STATE OF NORTH CAROLINA  
DEPARTMENT OF TRANSPORTATION

**Subject: Request for Modification and Renewal of the Section 404 Individual Permit and Section 401 Individual Water Quality Certification, and Catawba Riparian Buffer Authorization** for the Widening of NC 150 from the NC 16 Bypass in Catawba County to just west of the US 21/NC 150 Interchange in Iredell County, including the Interchange with I-77. Federal Aid Project No. STP-150(19), Division 12, TIP No. R-2307 and I-5717.

**References:** 1) Section 404 Individual Permit, Action ID No. SAW-2018-02343, issued September 3, 2020;  
2) Section 401 Individual Water Quality Certification and Catawba Riparian Buffer Authorization, NCDWR Project No. 20181732, issued April 17, 2019

**PERMIT DRAWING  
SHEET 2 OF 22**

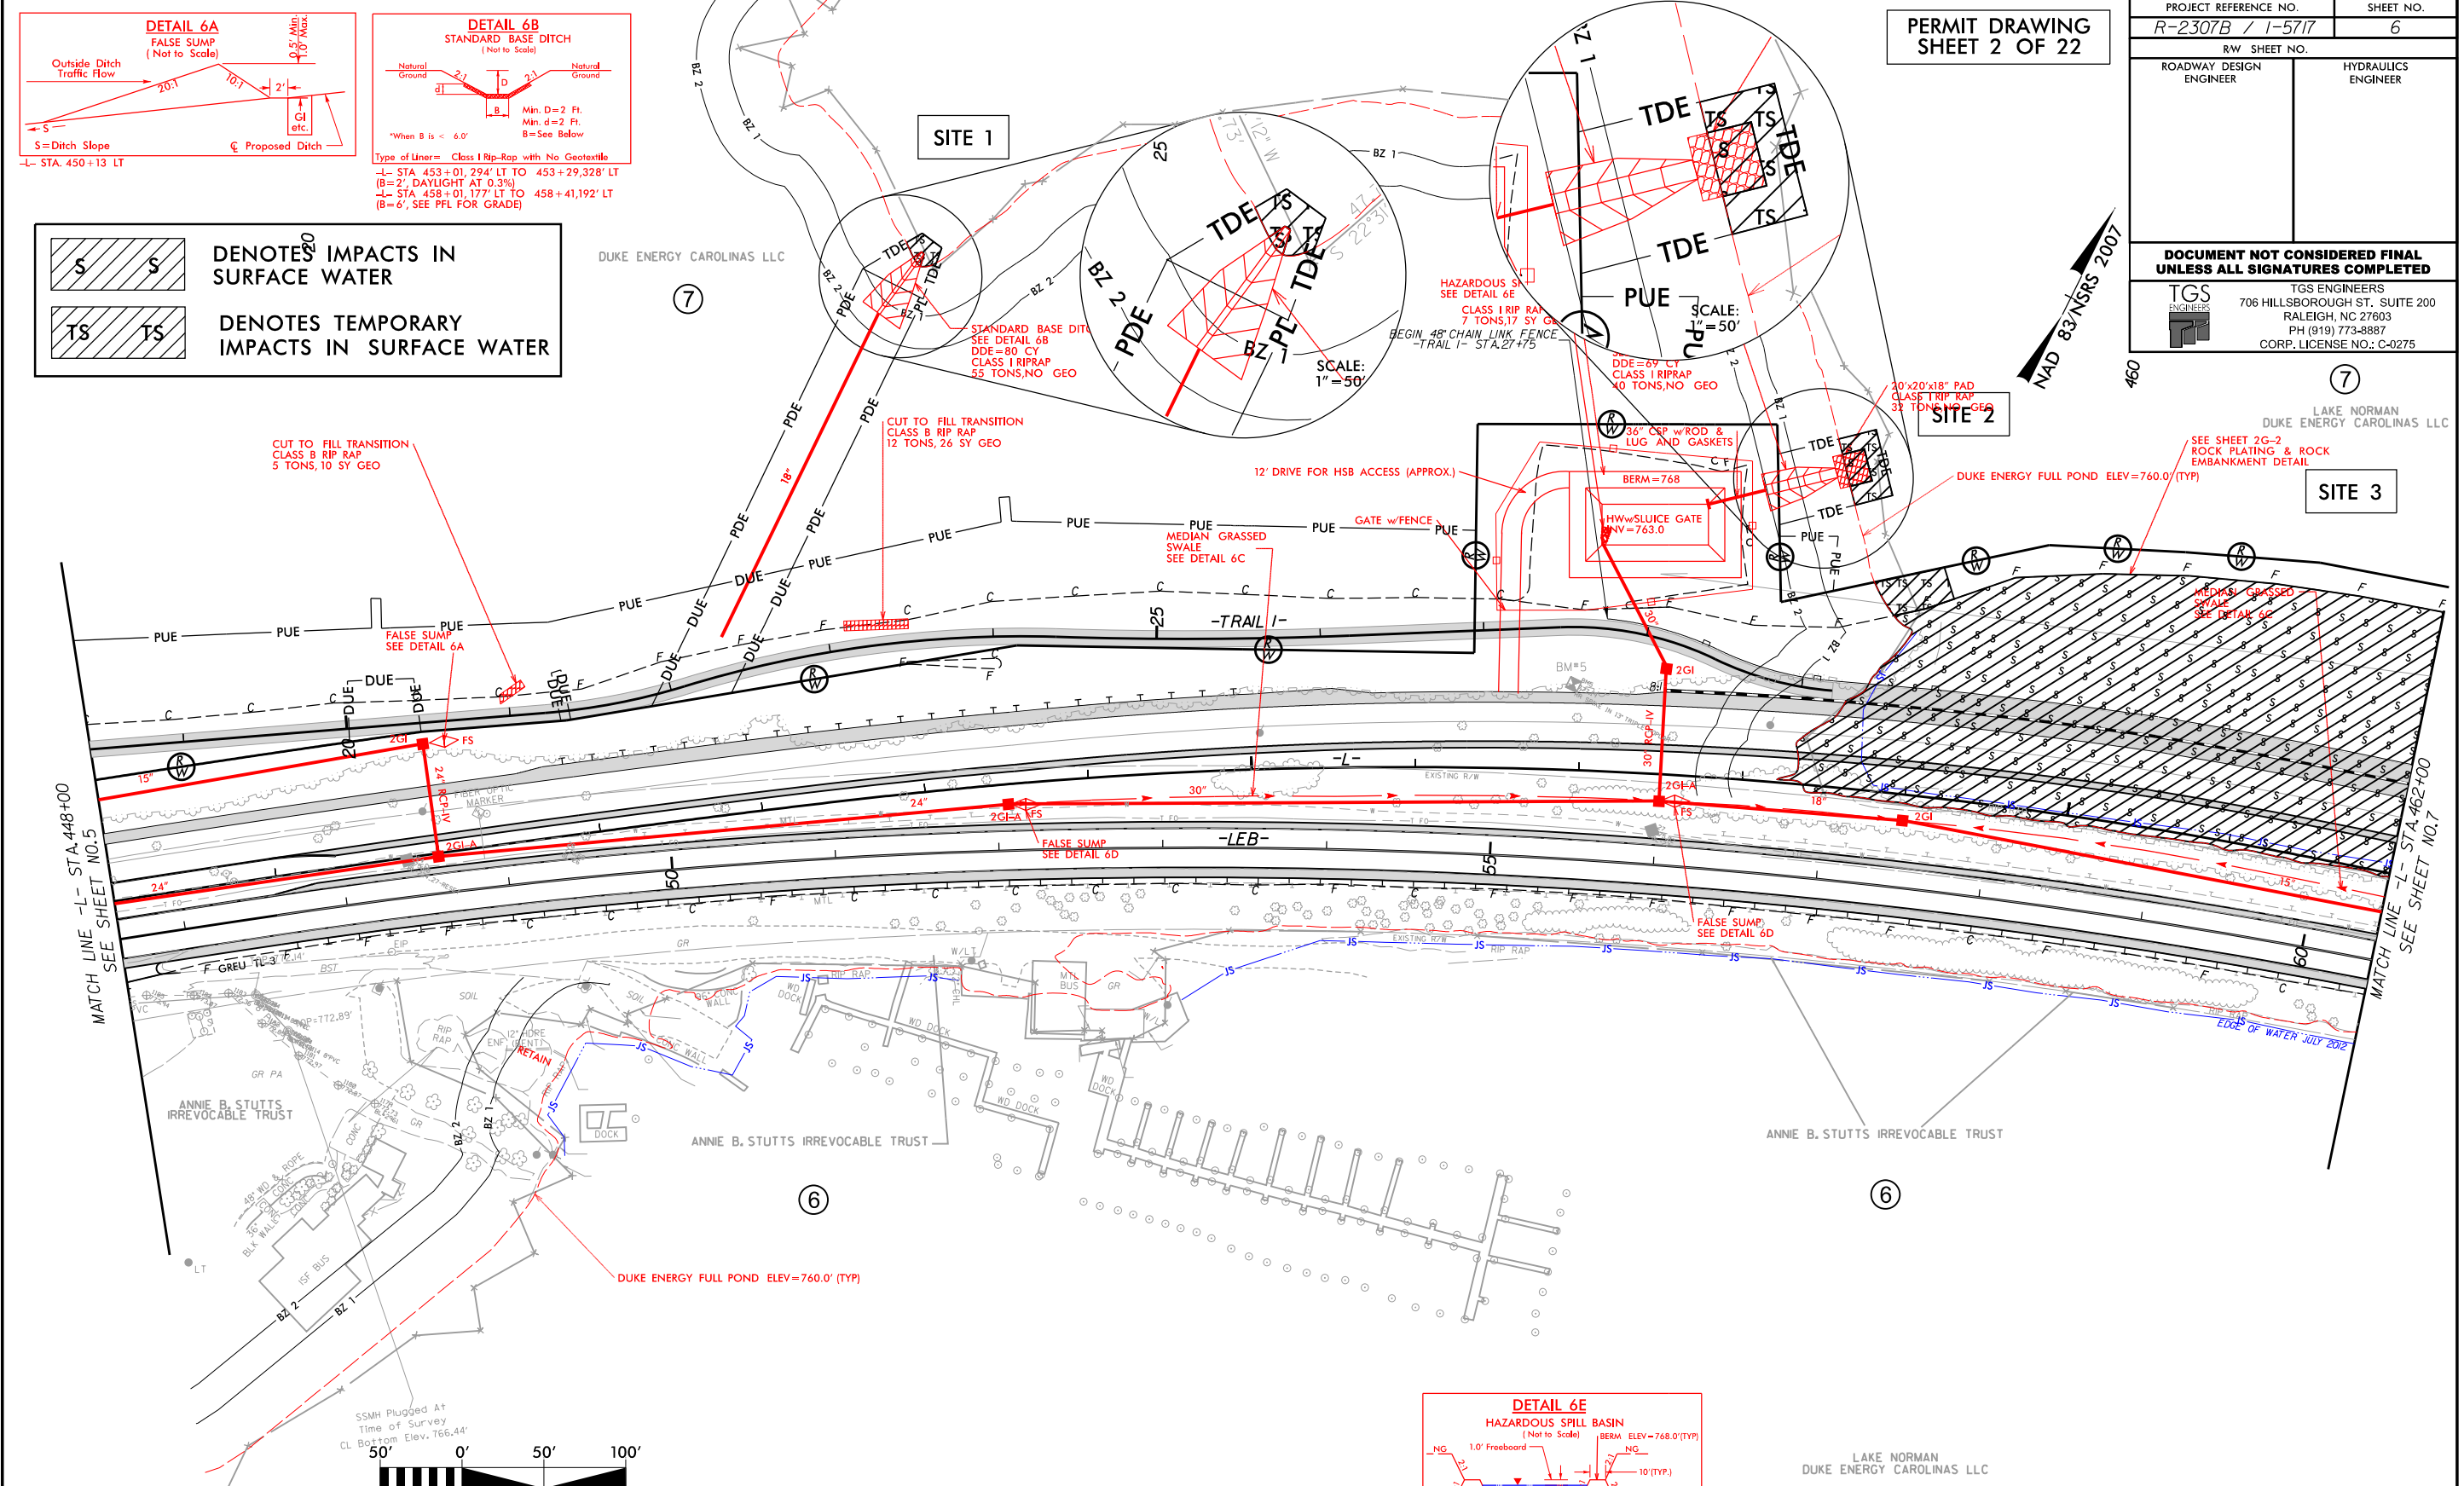
1. Site 3: Permanent Surface Water Impacts decreased from 3.11 acres to 3.079 acres due to minor slope stake changes at Lake Norman.
2. Site 3: Three temporary Surface Water Impacts were added down to elevation 750 ft on Permit Drawing Sheets 2-5. Temporary Surface Water Impacts increased from 0 to 0.070 acre.

PERMIT DRAWING  
SHEET 4 OF 22

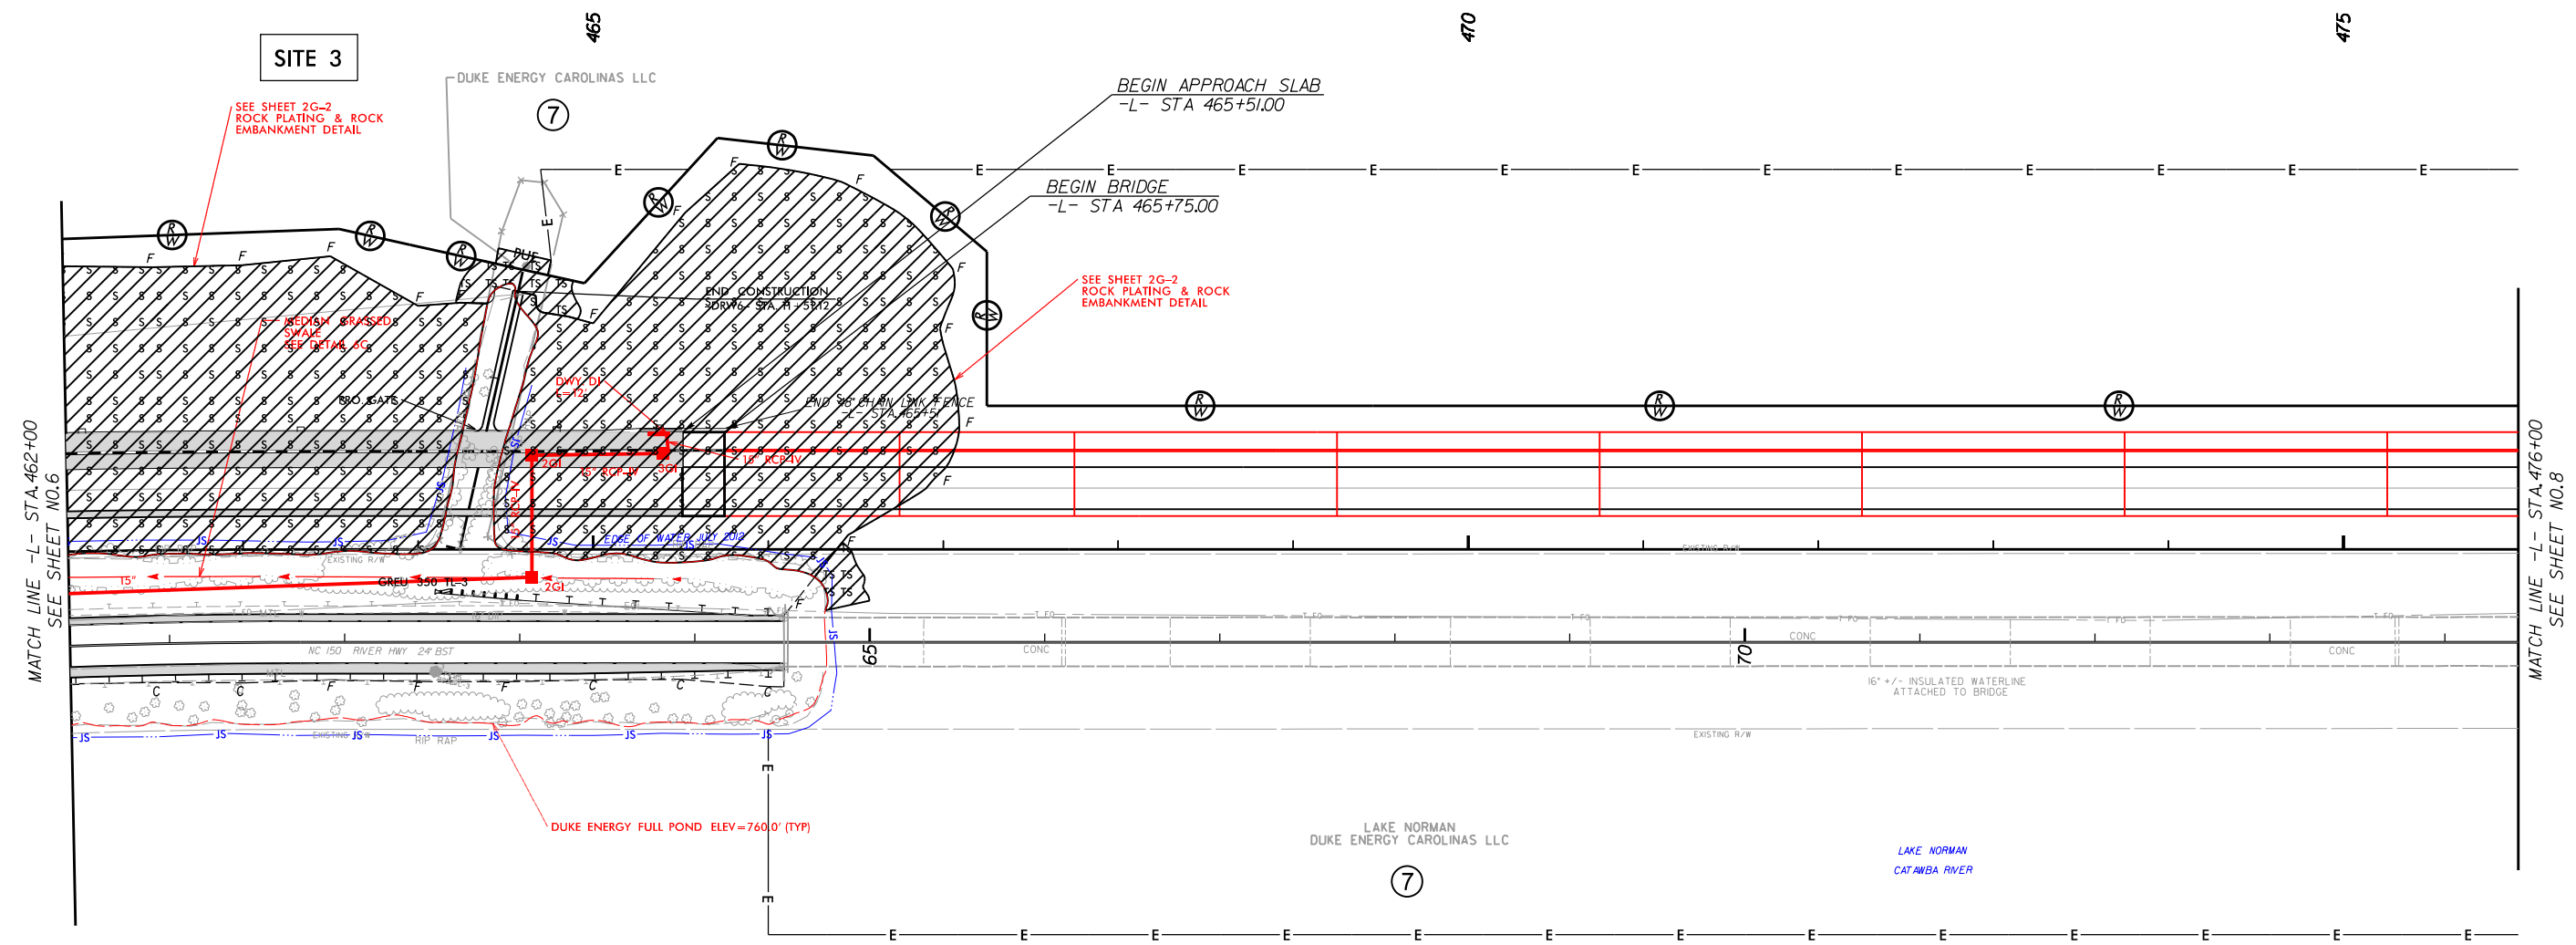
3. Due to concerns from Duke Energy regarding boater safety and the alignment of bridge piers with the existing structure, the proposed bridge span arrangement was modified to better match the existing bridge. Permit Drawing Sheets 4-6 and associated footnote on the Impact Summary Sheet were updated.

PERMIT DRAWING  
SHEET 7 OF 22

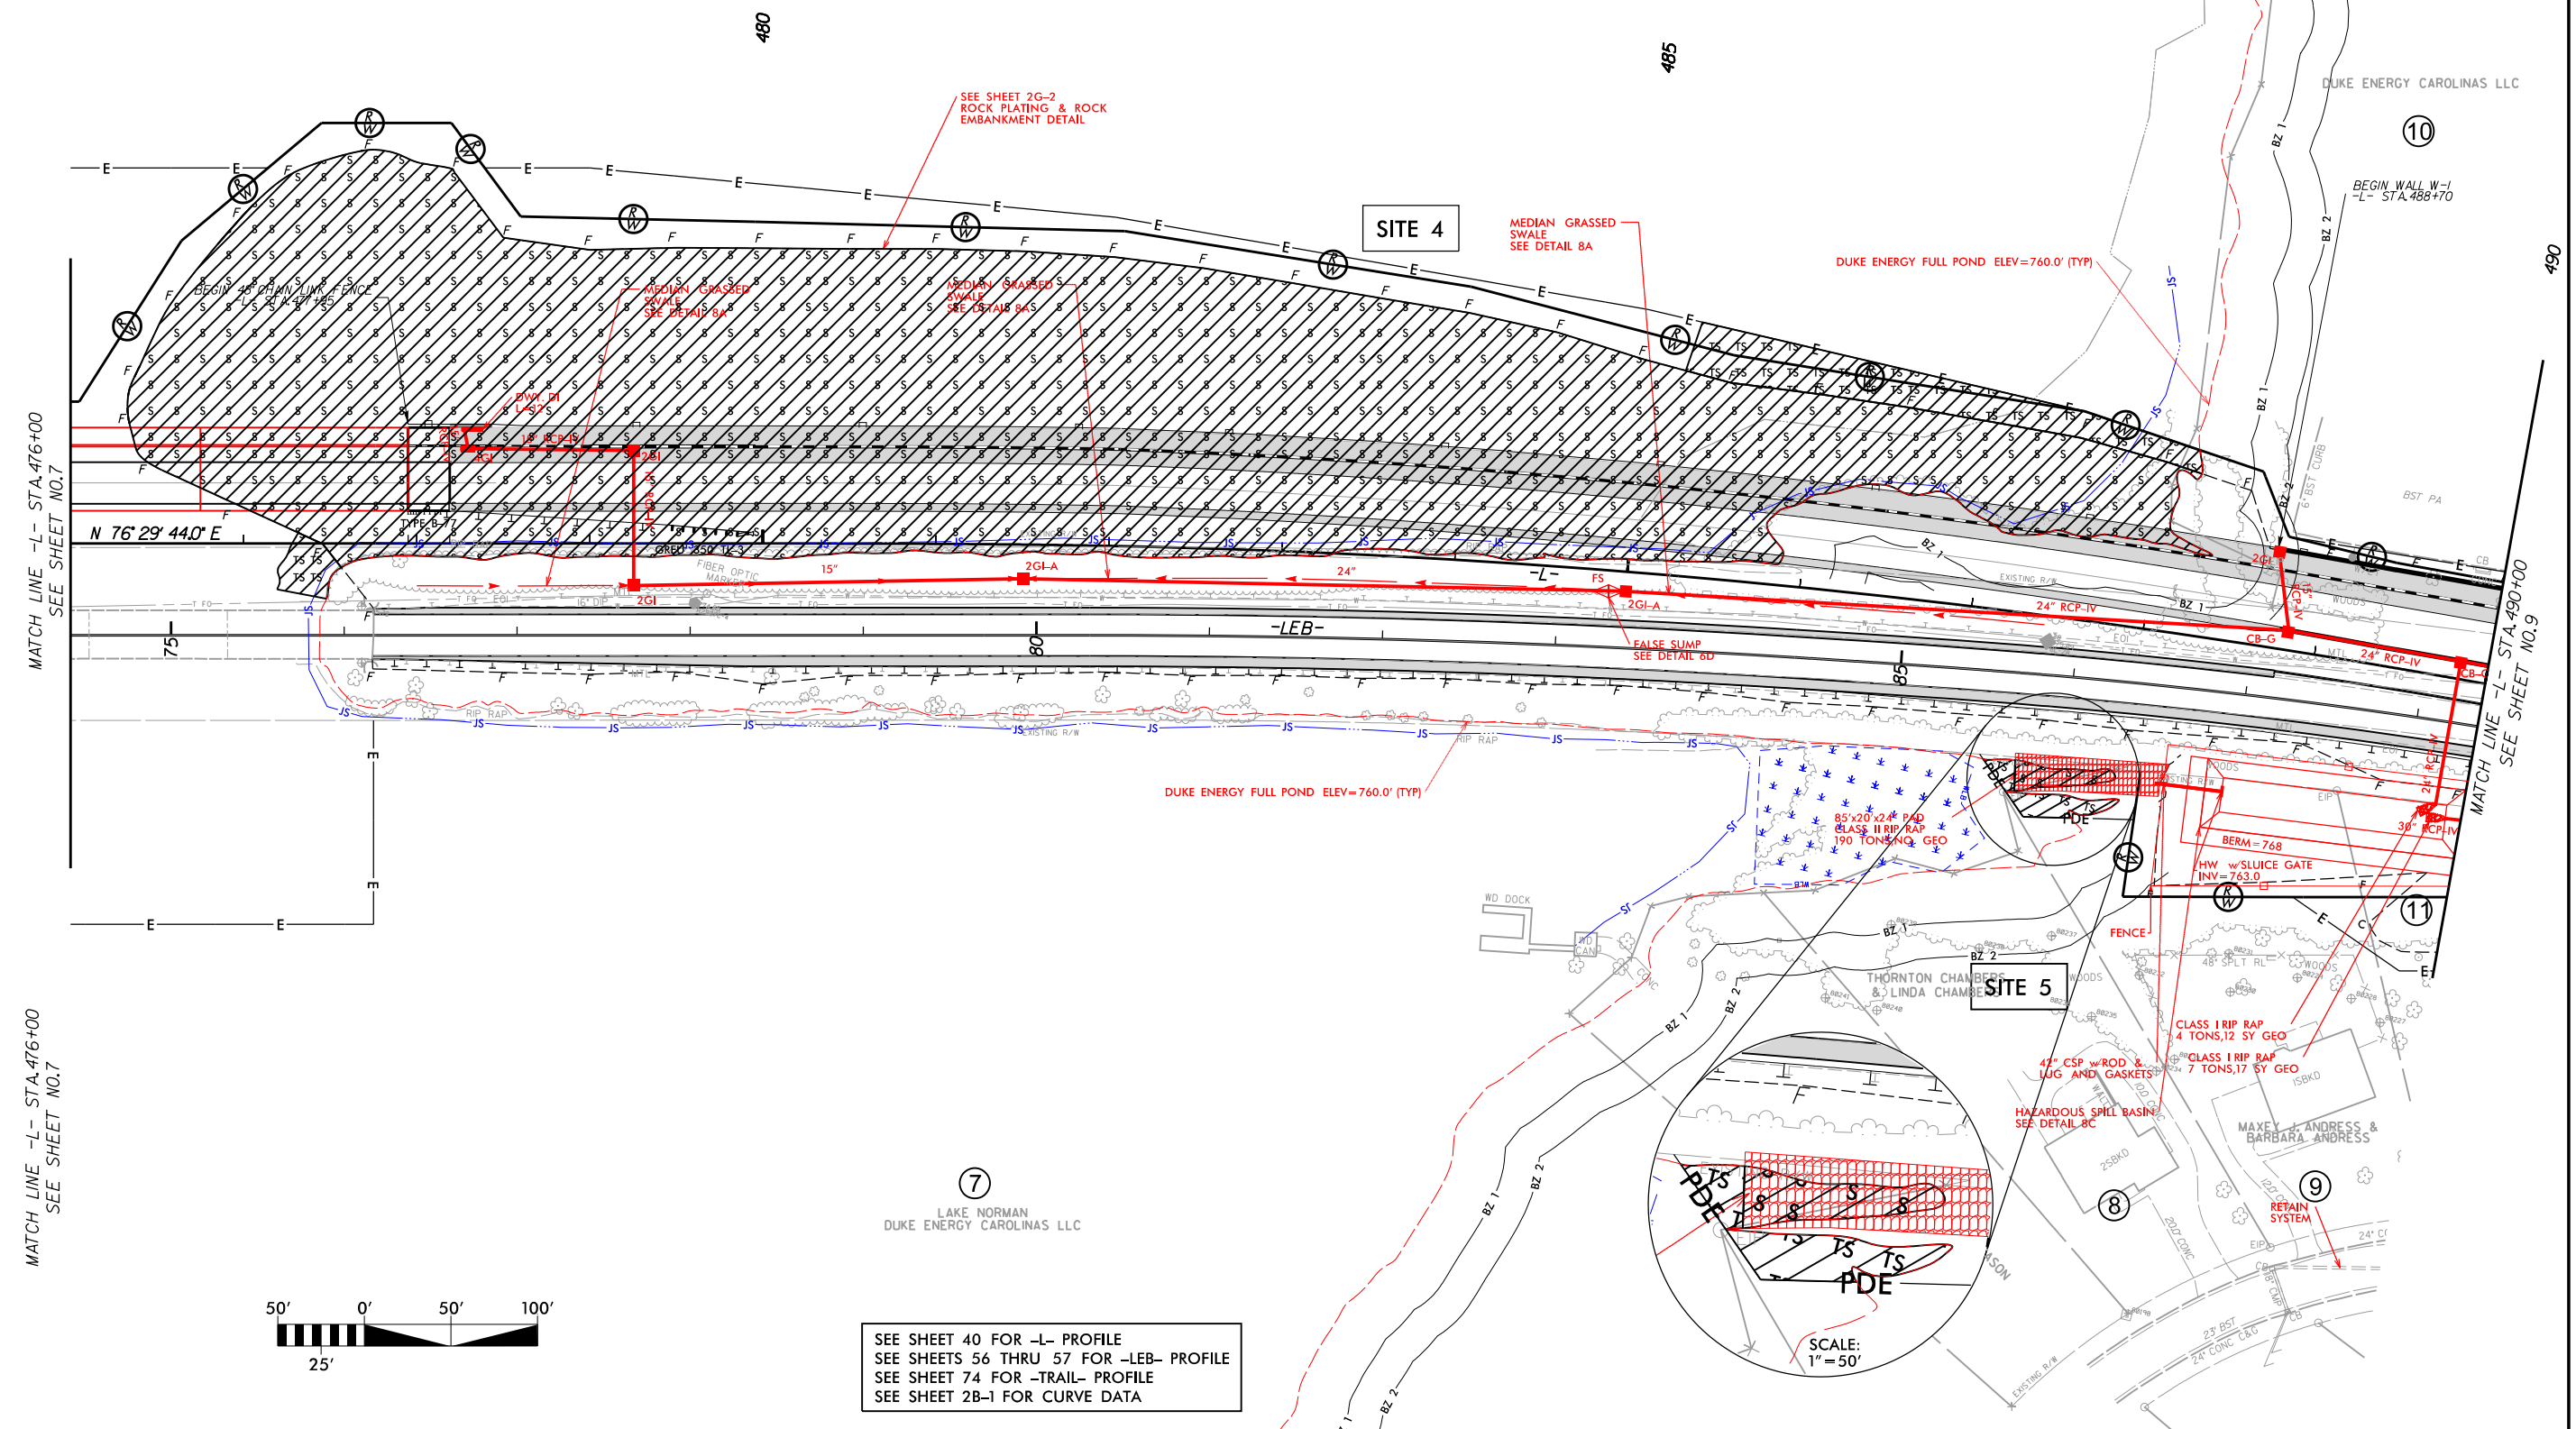
4. Site 4: Permanent Surface Water Impacts decreased from 3.91 acres to 3.859 acres due to minor slope changes at Lake Norman.
5. Site 4: Two temporary Surface Water Impacts were added down to elevation 750 ft on Permit Drawing Sheets 7-8. Temporary Surface Water Impacts increased from 0 to 0.162 acre.
